# Environmental Minor Project Refinement Form

Project Name: West of Devers Upgrade Project Request Prepared By: Sylvia Granados

Date Approval Required: 5/29/2018 Variance Request No.: 14

Specify Source (e.g., Mitigation Measure B.5): Modification to NTP #3 Subtransmission Work Area Mapping.

FIGURE 4

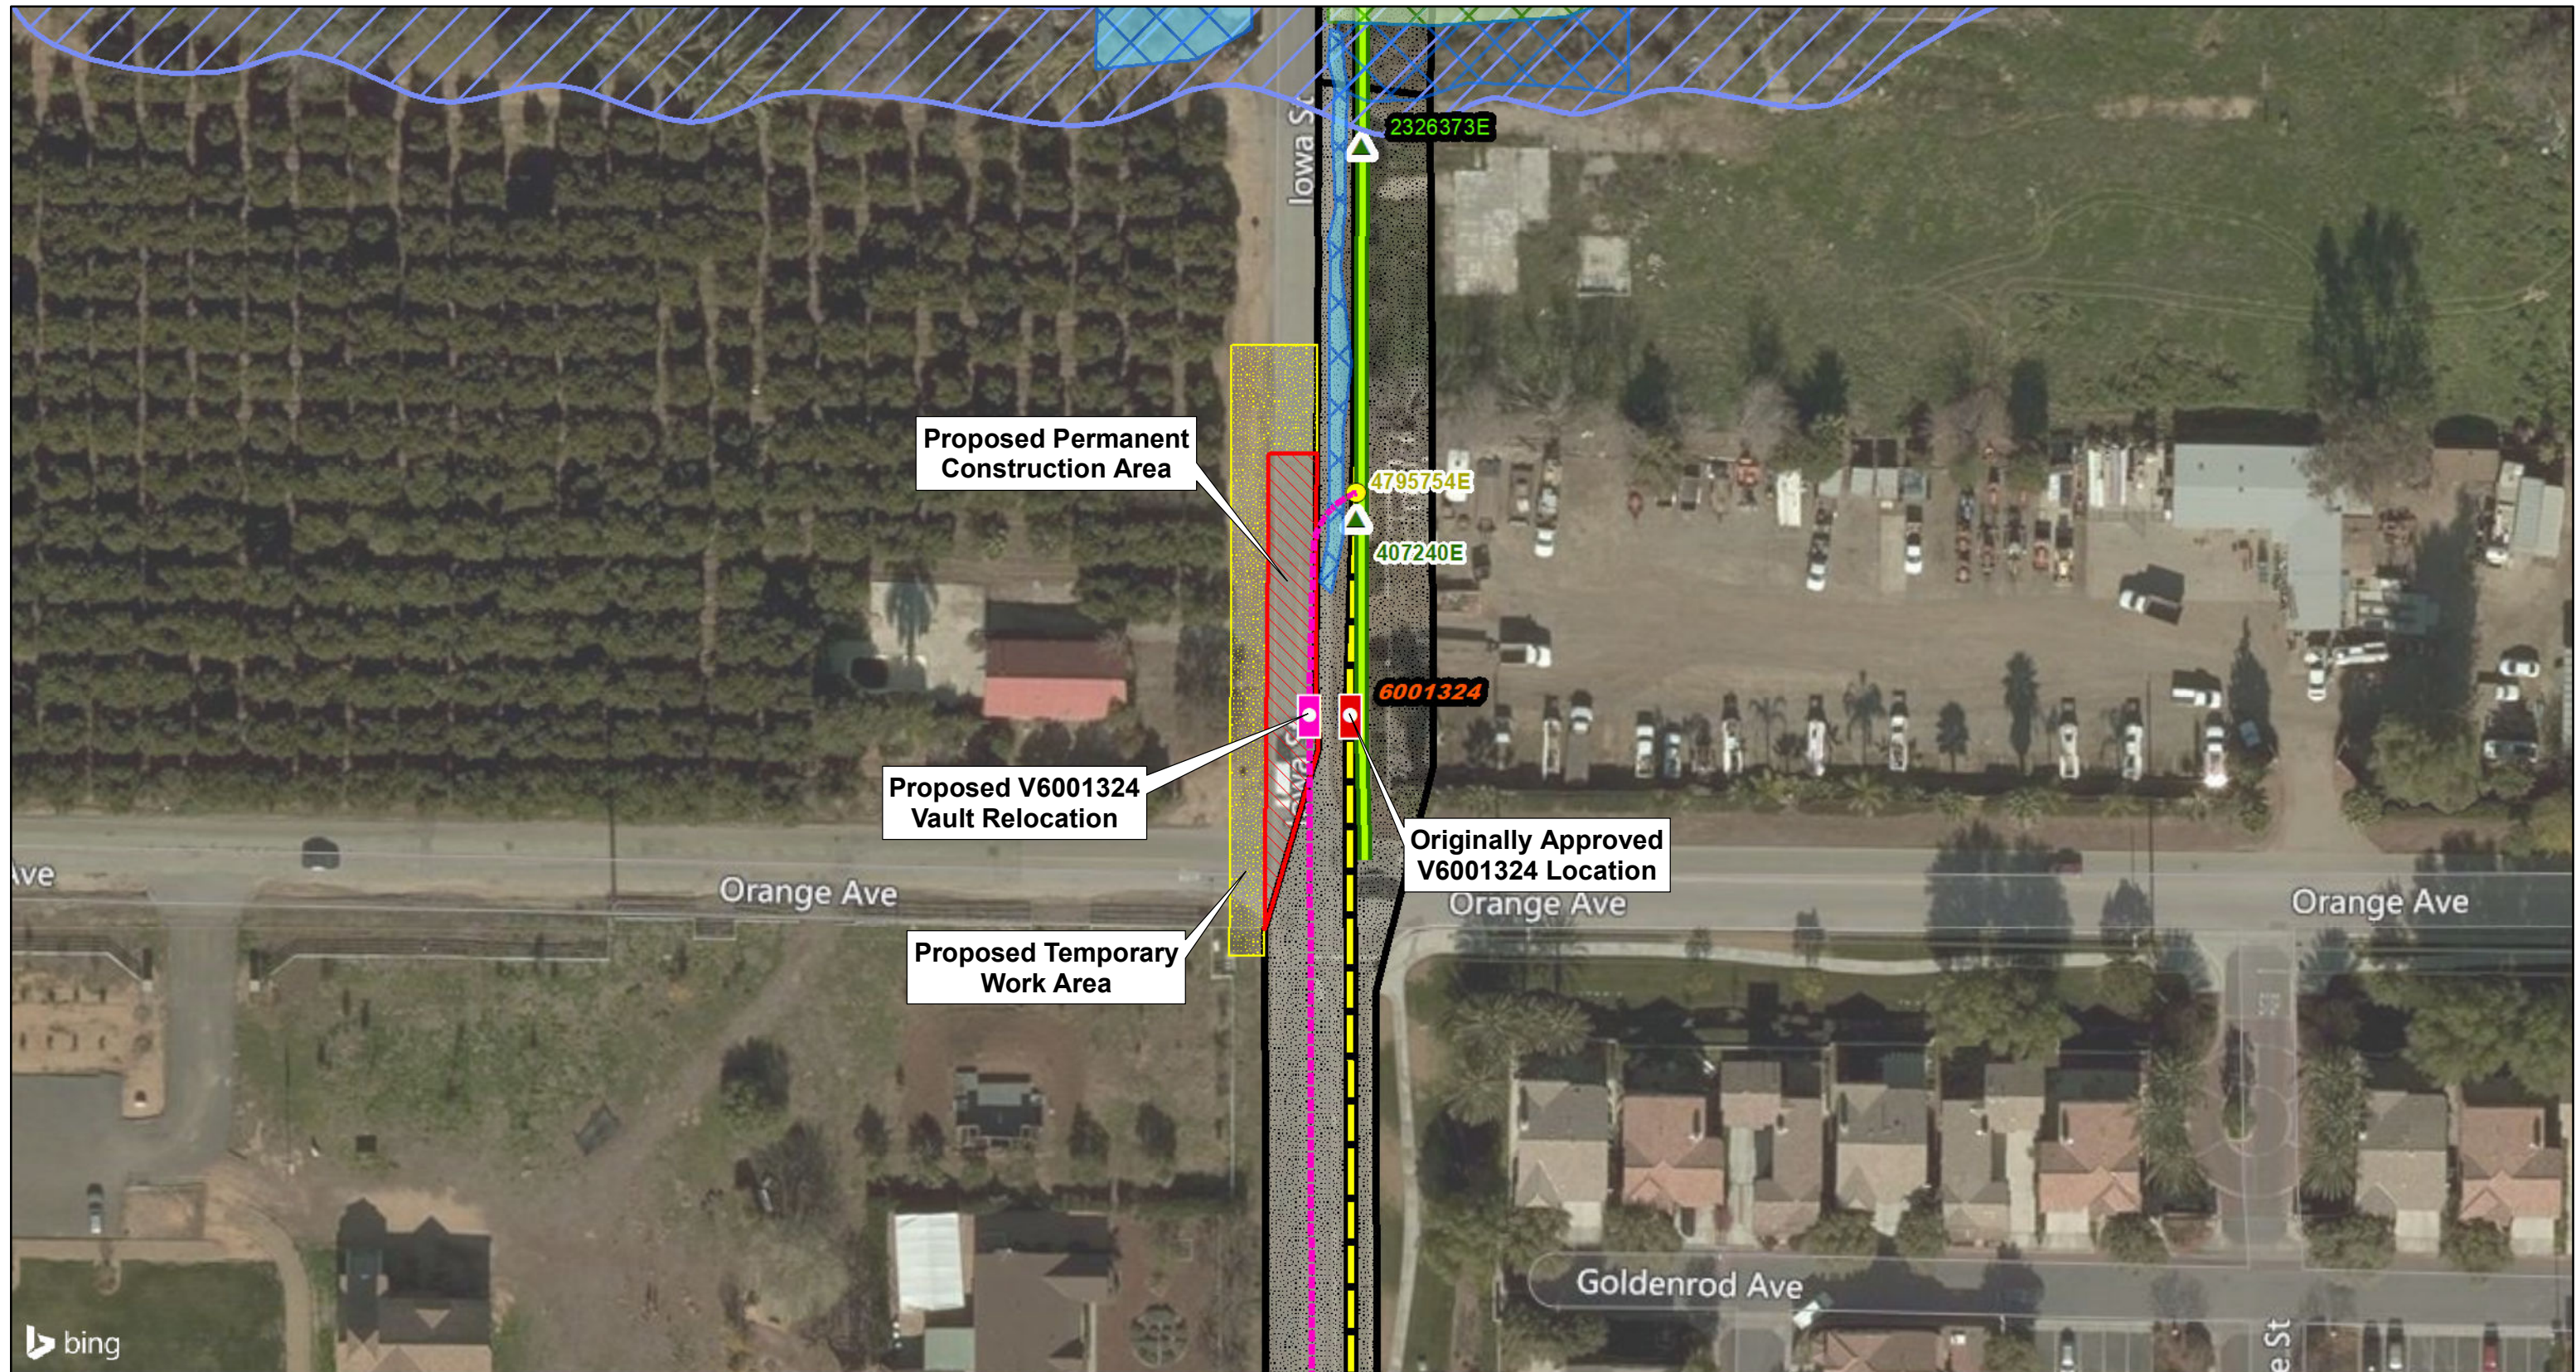
### **Vault V6001324 installation in front of 11090 Iowa Street, in the City of Redlands**

Due to underground utility conflicts encountered in the approved work area, a portion of the San Bernardino–Redlands–Tennessee subtransmission line and vault V6001324 require adjustment to the center of the road north of the intersection of Iowa Street and Orange Avenue, in the City of Redlands, as shown in Figure 4.

The temporary impacts to developed/disturbed land associated with the redesign are .15 acre.

Jurisdictional Waters – A jurisdictional feature is located north of Orange Avenue between structures 436540E and 2326373E. The jurisdictional feature, which intersects the work area, will be conspicuously staked for avoidance during construction activities.

Listed Riparian Birds – The work area along Iowa Street includes suitable habitats for riparian birds. Changes proposed in this MPR are located within 500 feet of a riparian habitat patch along Iowa Street, between Citrus and Orange. Beginning April 10, 2018, least Bell's vireo biologists John Green and Stephen J. Myers began least Bell's vireo protocol survey visits at this location. Both biologists are also authorized to survey for southwestern willow flycatcher under the authority of recovery permits TE054011-7 (Green) and TE804203-11 (Myers). Flycatcher surveys began after May 15 according to the protocol. No least Bell's vireo have been observed. Willow flycatchers have been observed in the habitat patch. However, migrant willow flycatchers of several subspecies are relatively common in passage in many southern California habitats. Migrants of that kind have been detected in the subject patch in the past. None stayed and none were considered the "southwestern" willow flycatcher subspecies. Due to the low and degrading quality of the habitat, lack of historic occurrences, and lack of presence over multiple years of project surveys, southwestern willow flycatchers are not expected.
